Department of Energy
Washington, D.C. 20545

Docket No. 50-537
HQ:S:82:148

ADDITIONAL INFORMATION RESULTING FROM DECEMBER 15, 1982, MEETING ON PLANT
AUXILIARY SYSTEMS, PRELIMINARY SAFETY ANALYSIS REPORT (PSAR) CHAPTER 9

RESPONSES TO NRC COMMENTS

Figure 2. Corrosion of Austenitic Stainless Steels in Sodium Hydroxide

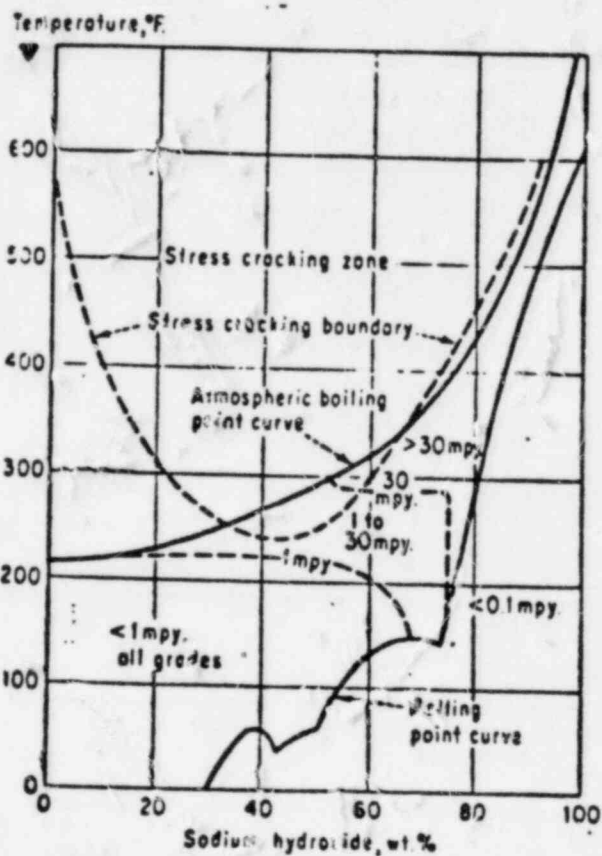
Comment: Caustic-induced stress corrosion cracking of the process system and the components to be cleaned should be evaluated.

Response: For the stainless steel materials used, the stress cracking regime due to NaOH has a lower temperature boundary of approximately 240°F as shown in attached Figure 2 of article by R.E. Swanby "Corrosion Charts: Guides to Material Selection", Chemical Engineering 69:22, 186-201 (November 12, 1962). Expected process temperatures are below 200°F. Hence, stress corrosion cracking is not considered to be a problem for either the process system or the components cleaned.
